CDM: Form for submission of queries from DOEs to the Methodologies Panel regarding the application of approved methodologies (version 01.1)

Name of the entity (DOE) submitting this form	TÜV NORD CERT GmbH
Reference number and title of the approved methodologies	ACM0002 (Version 10): Approved consolidated baseline and monitoring methodology "Consolidated baseline methodology for grid-connected electricity generation from renewable sources"
Title/Subject (give a short title or specify the subject of your submission, maximum 200 characters):	Clarification of definitions (<i>plant</i> and <i>facility</i>) in the context of two or more renewable energy plants (geothermal or hydro) sharing the same resources.
Attach CDM-PDD example of project activity where applicability raises problem:	<input type="checkbox"/> Yes, is attached.
Date and signature for the DOE	2012-12-14  (Rainer Winter)

ACM0002 (Version 10): Approved consolidated baseline and monitoring methodology
 ``Consolidated baseline methodology for grid-connected electricity generation from renewable sources`` for Geothermal Project

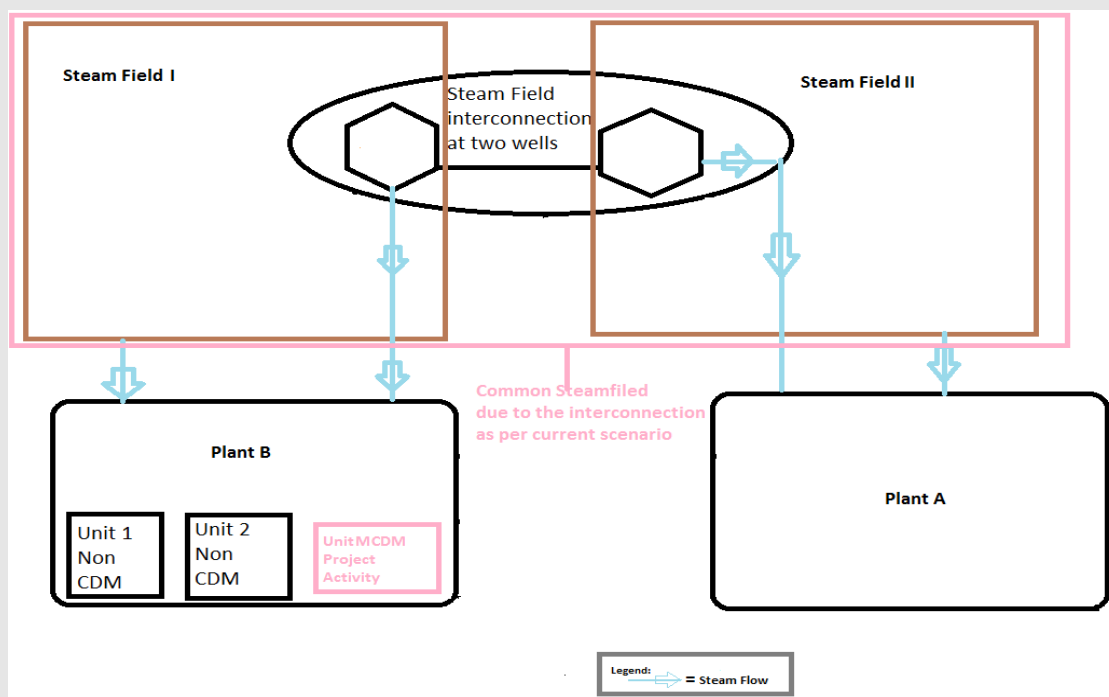
The CDM project consists of an additional unit within an existing plant consisting of several units. Further to this there is a neighbouring plant of similar structure. Both plants share the same resource (i.e. interconnected steam fields) with significant/abundant potential¹ i.e. before and after the capacity addition done by the project activity.

The below diagram illustrates such a situation:

In the given context a **unit** has been added to an existing **plant**. Clarification is sought whether in such a case only all the units within the plant (to which the CDM unit is added) needs to be considered and included in the project boundary (Approach # 1) or all units of this plant and all other plants (the plant containing the CDM Unit + non CDM plant) which share the resources are to be considered (Approach # 2).
